UNITED STATES PATENT AND TRADEMARK OFFICE

APPLICATION NO.	FILING DATE	FIRST NAMED INVENTOR	ATTORNEY DOCKET NO.	CONFIRMATION NO.
09/920,640	08/03/2001	Steve Mead	12440-02/ejg	6057

Office Action Summary

DETAILED ACTION

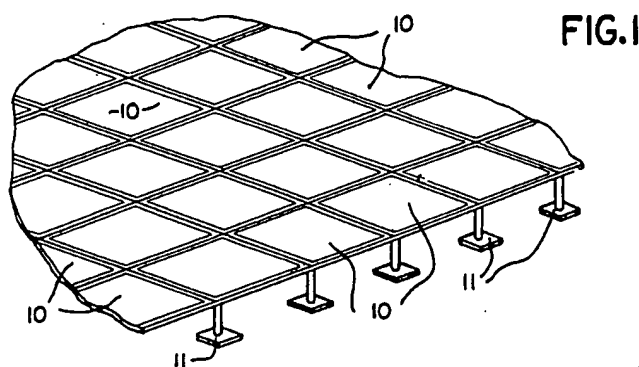
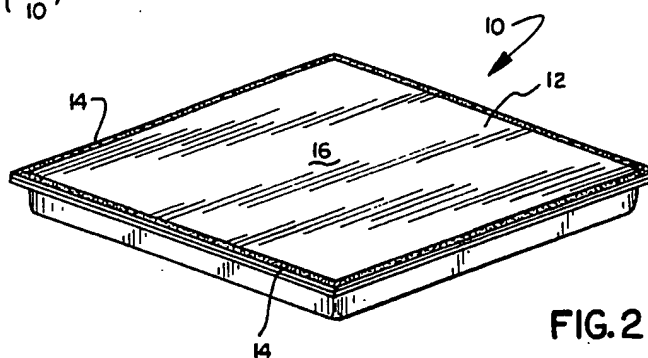
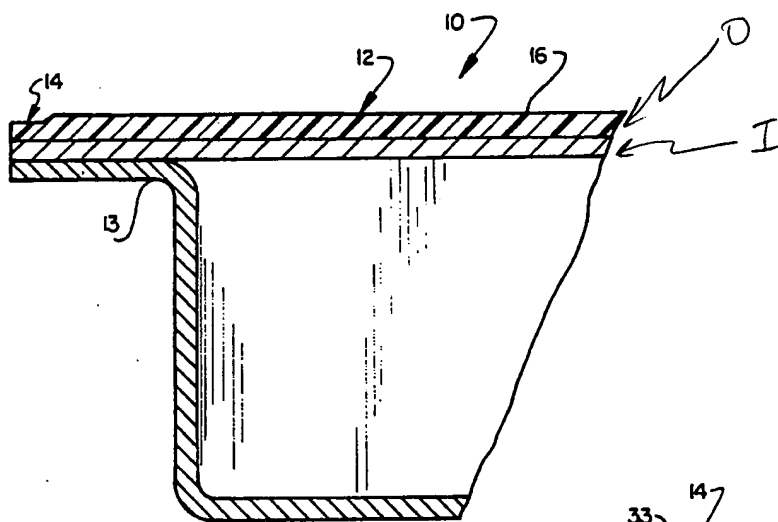
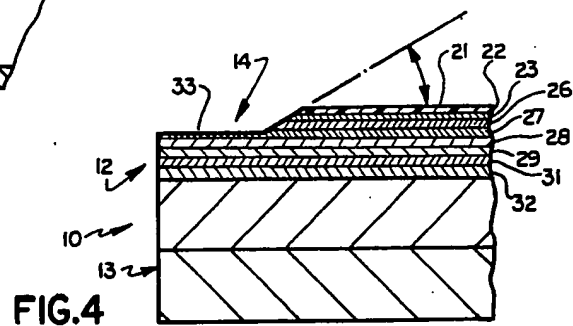
and outer (O) panels adhesively bonded thereto, column 3, line 19, see the marked-up attachment. The outer panel (O) further includes a border as at (33). Regarding claims 2 and 3, the outer panel (O) includes a decorative surface (23 and 26-29); and the inner panel (I) includes another decorative surface (31,32). In reference to claims 4 and 5, the inner (I) and outer (O) panels both are formed as high-pressure laminates, column 3, line 38. Regarding claim 6, both the inner and outer panels (I,O) include high wear films, column 3, line 36.

inner (I) and outer (O) panels adhesively bonded thereto, column 3, line 19, see the marked-up attachment. The outer panel (O) further includes a border as at (33). GIBSON discloses the basic claimed elevated floor except for the panels are square as opposed to being rectangular. However, it would have been obvious to one having ordinary skill in the art at the time the invention was made that the shape of the panels would be an obvious matter of design choice. Further, rectangles and squares are generally the same except for the length, thus the selection of either would have been within the general skill of a worker in the art. The shape of the panels basically determines the overall external appearance. In reference to claim 8, the inner panel (I) includes a dark surface (31,32) and the outer panel (O) includes a decorative surface (23, 26-29). Regarding claim 9, the outer panel (O) further includes a clear resin film (22). In reference to claim 10, a clear resin film is provided between both the inner (I) and outer (O) panels, column 3, lines 33-35. Regarding claim 11, a plurality of the panels (10) are arranged in abutting edge-to-edge relationship to form an elevated floor, see Figure 1. In reference to claim 12, the method of forming the base panel is not germane to the issue of patentability of the device itself. Thus, the fact that the base panel is stamped to be formed has not been given patentable weight. Further, the base panel 913) of GIBSON is made from sheet steel, column 2, lines 47-48.
